RFP ADDENDUM

ADDENDUM NO.: 003

DATE ISSUED: April 11, 2024

SITE UTILITIES
 REDEVELOPMENT OF THE JOHN DAVIS RECREATION CENTER
 CITY OF DALTON
 904 CIVIC DRIVE
 DALTON, GEORGIA 30720
 GREGG SIMS, ARCHITECT AIA/NCARB/LEED AP
 904 SELVIDGE STREET | P.O. BOX 219 | DALTON, GEORGIA 30722
 VOICE: 706.226.5796 | FACSIMILE: 706.226.1123 | g@greggsims.com

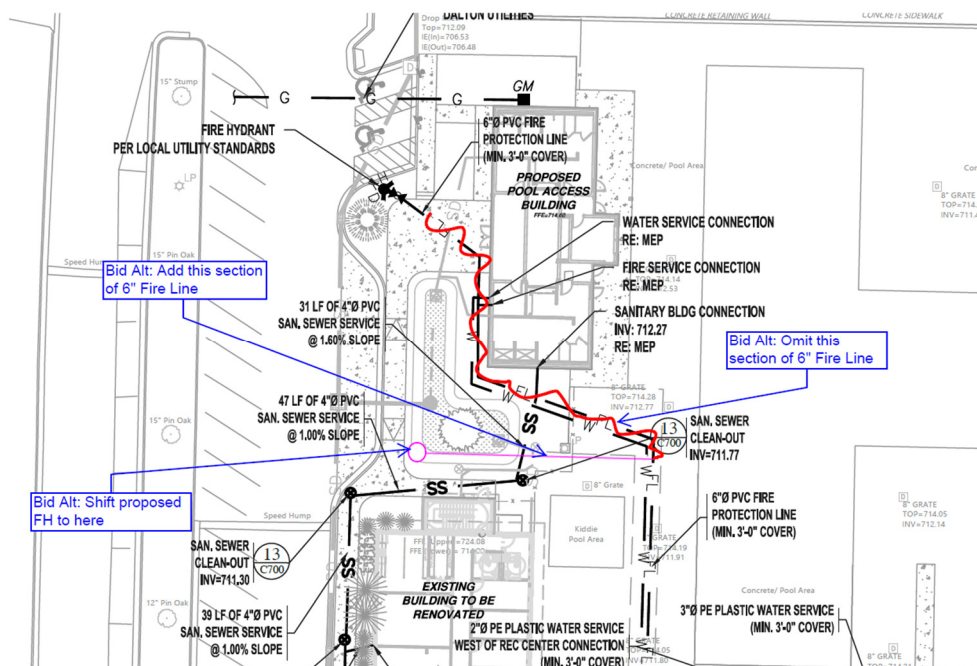
b. Item 25. Fire Protection: Fire Protection subcontractor to provide two proposal costs as follows:

(2) Cost for Fire Protection for Recreation Center facility only. Omit the 6” PVC fire lines from just past the baby pool area to the Pool Access Building. Relocate the proposed fire hydrant from the pool building frontage to just southwest of the bio-retention pond. See below:

25' - 30' POLE BASE DETAIL
 N.T.S.

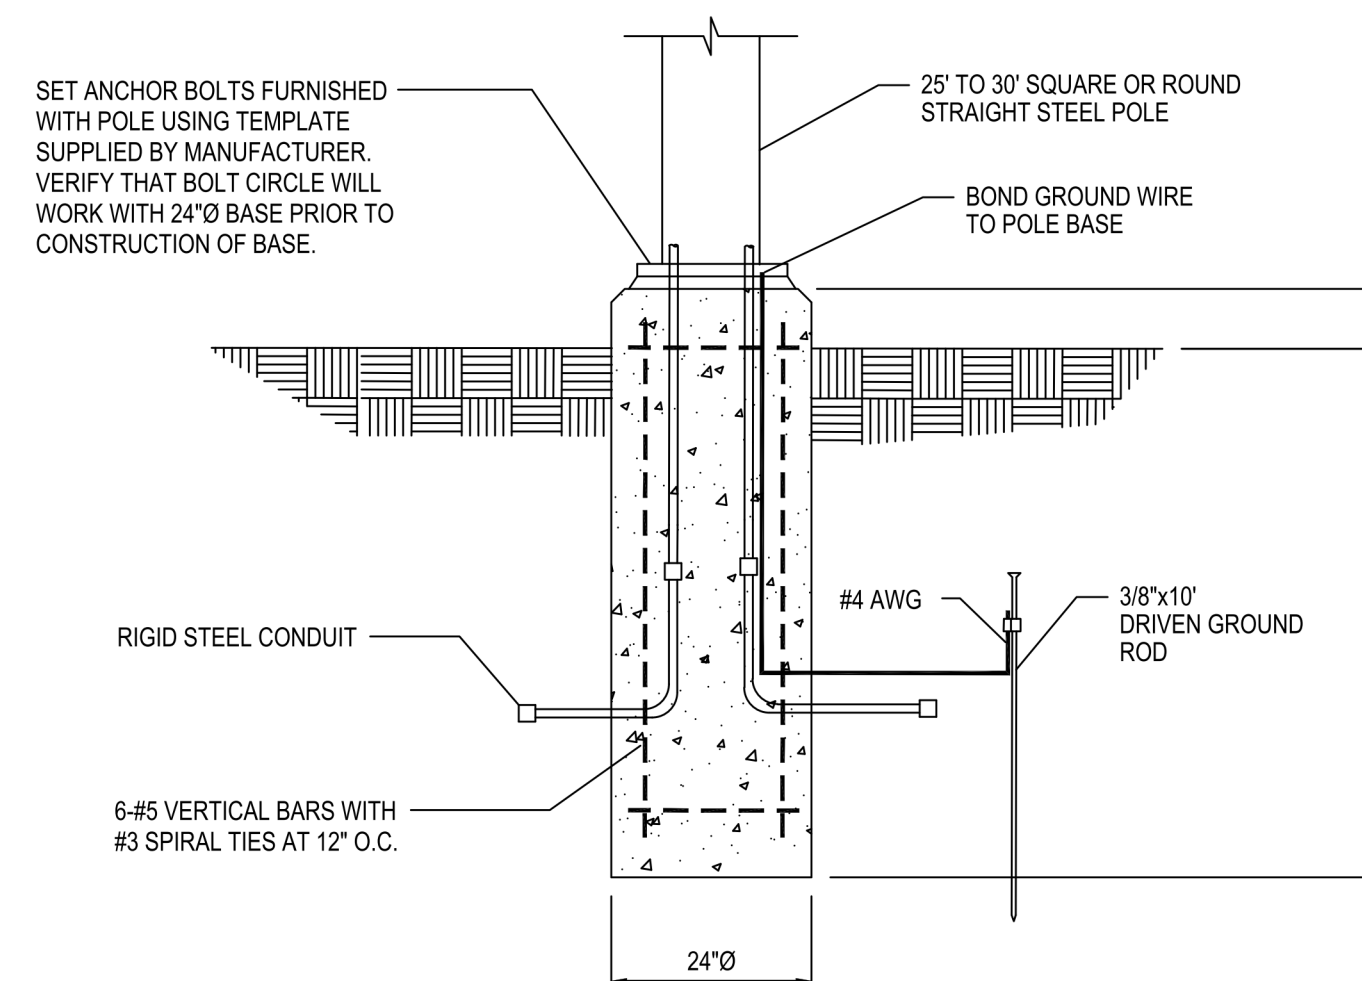
3. "Who is responsible for the concrete Pole bases for the exterior pole lights around the pool?"

Answer: See General Site Note 4 on E1S.00: RC Electrical Site Plan: The electrical contractor is responsible for supplying all concrete and related work for all pole bases, transformer pads, etc., which are in his scope of work.
